Addendum No. 3

**Post Point Sludge Tank Replacement Project
City Project No.: EU194
Bid Number: 3B-2026**

October 15, 2026

DRAWING NO.
420E104
SHEET NO.
113 OF 198

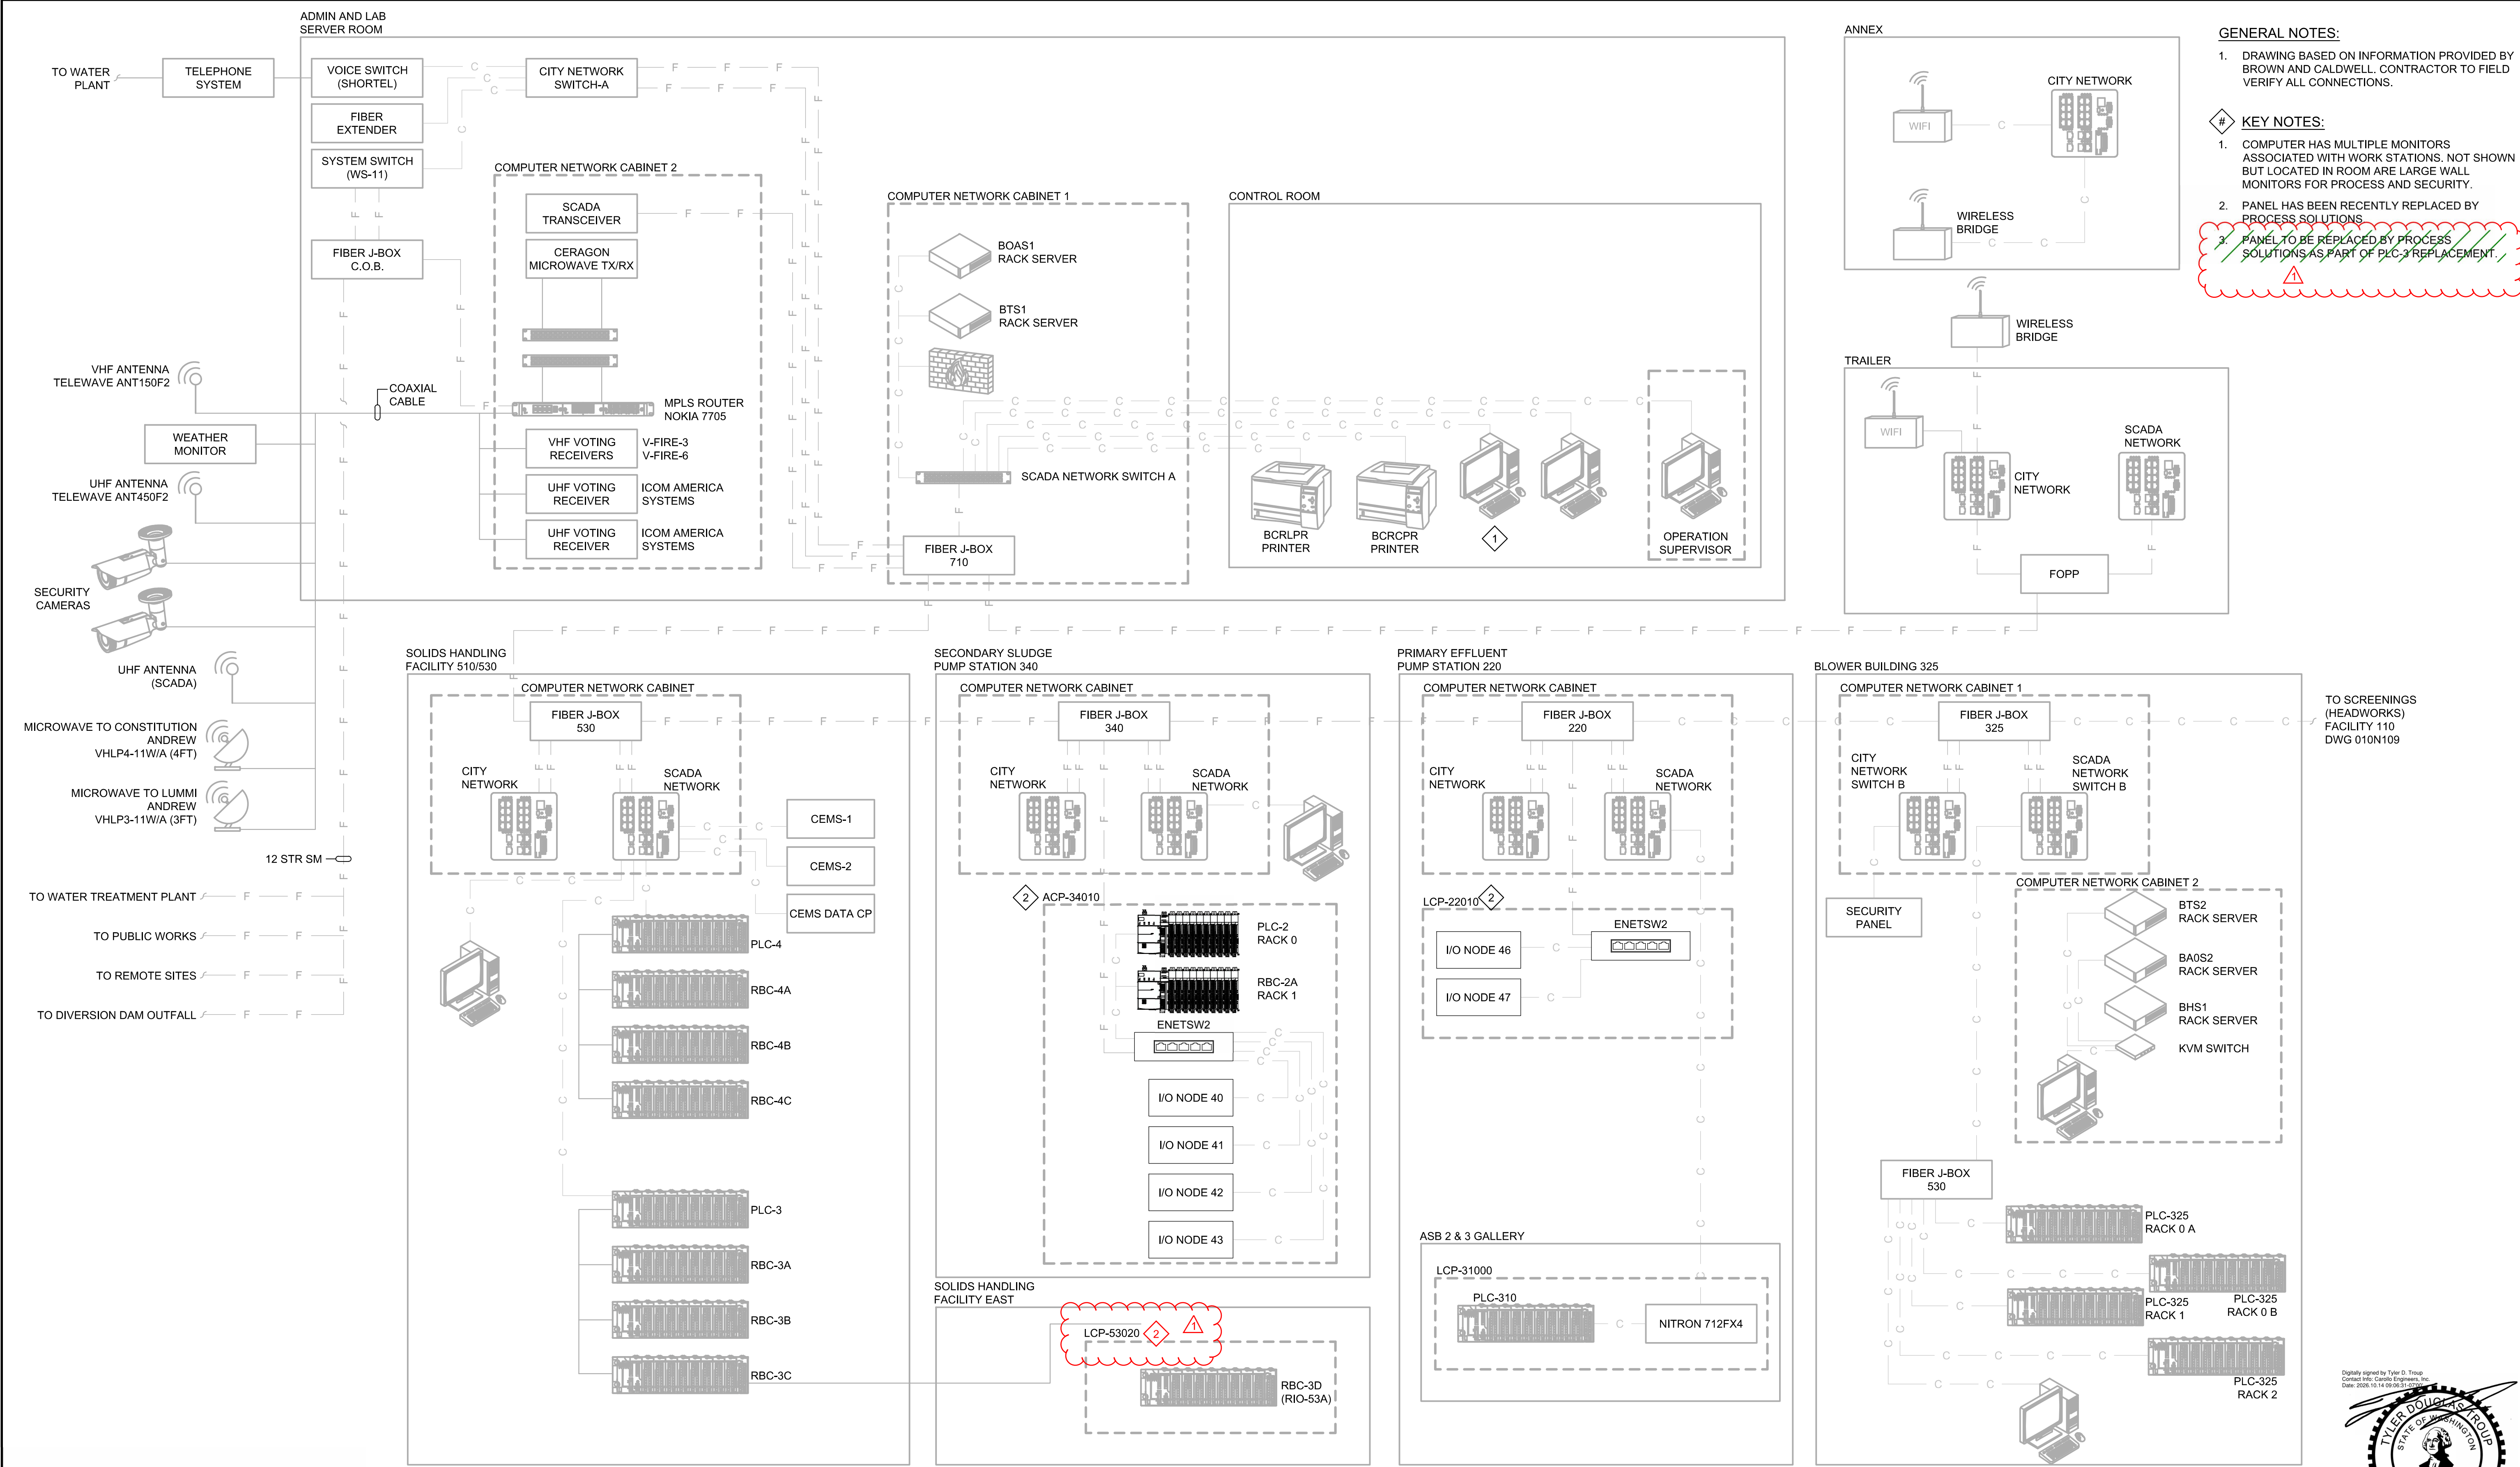
- 8. Drawing 420E104 – SLUDGE STORAGE BUILDING LOWER LEVEL POWER AND CONTROL PLAN
 - a. **DELETE** and **REPLACE** in its entirety. Drawing provided as Attachment A in this Addendum.

Response: Correct destination for Section 26_06_03 conduit C-440-300 is LCP-42020 (not MCC-42001) as shown on Drawing 420E104. See Attachment B for updated conduit schedules.

Temporary Cantilever Sheetpile Shoring

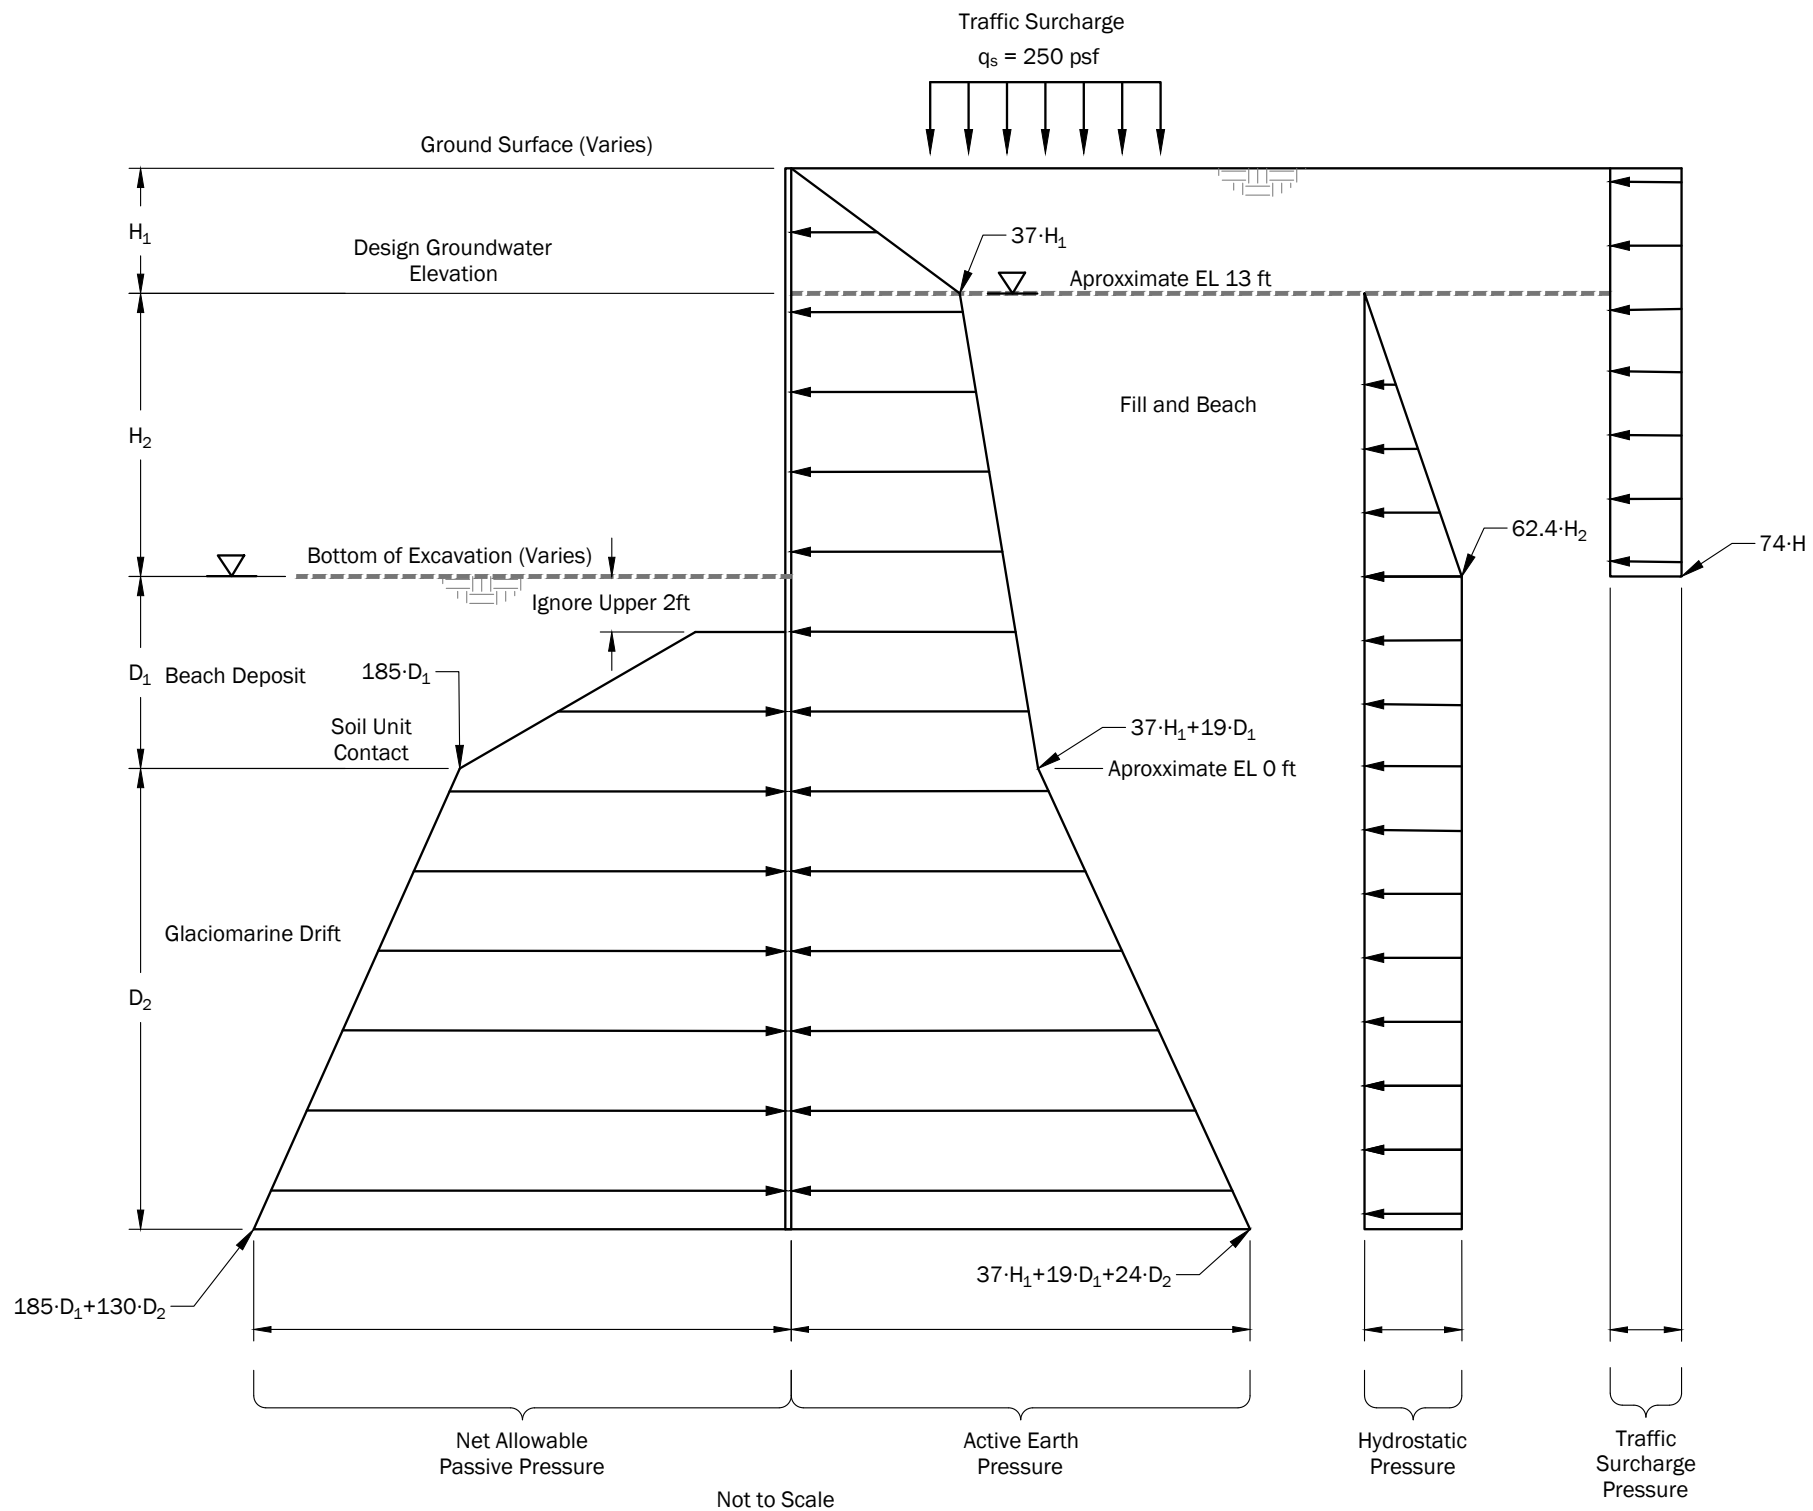
2. Question: Please reference 31 50 00 2.01 B 1 h, which specifies a maximum total deflection of 1/2 inch on sheetpile. Please advise if this maximum deflection can be increased to 1 inch.

Response: The maximum deflection can be increased to no more than 1-inch insofar as the shoring system designer can show no impact on the buildings or infrastructure surrounding the excavation. Whereas no impact is defined as not causing additional settlement to the surrounding structure and infrastructure.
